Summary	PathWatch wiring change				
Products Affected	All doors with PathWatch LED's				
Key Word Tags					
Tools/Equipment (If Required)	Precision Screw Driver				
Parts/Materials (If Required)					
Related Media					
Author	Mike Burzlaff	Issue Date	2/9/22	Status	Active

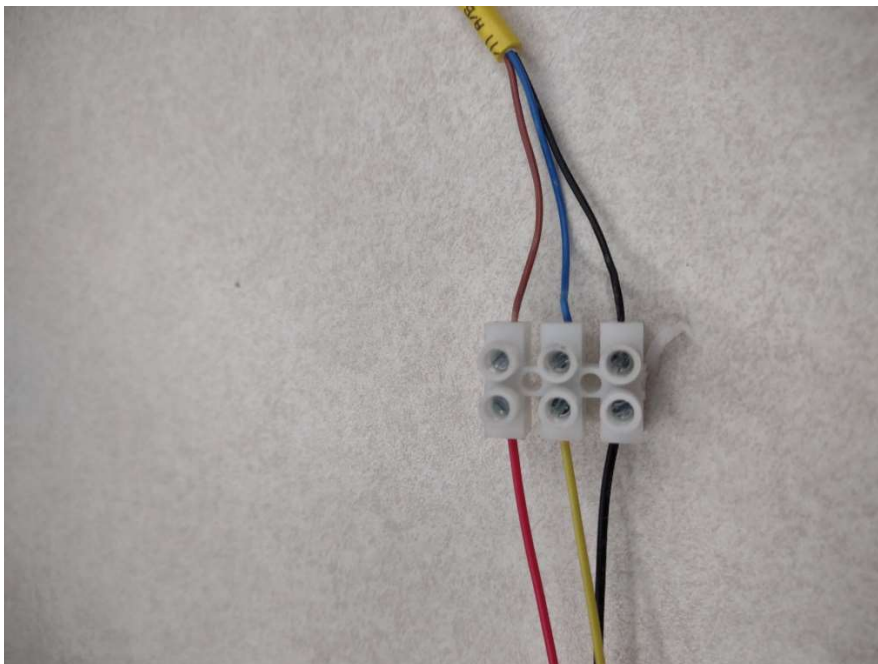
Due to supply chain issues, a deviation from the standard PathWatch wiring has become necessary. The wires from the LED will need to be connected directly to the white connection block in the field.

The Black wire will connect opposite of the other Black wire.

The Blue wire will connect opposite of the Yellow wire.

The Brown wire will connect opposite of the Red wire.
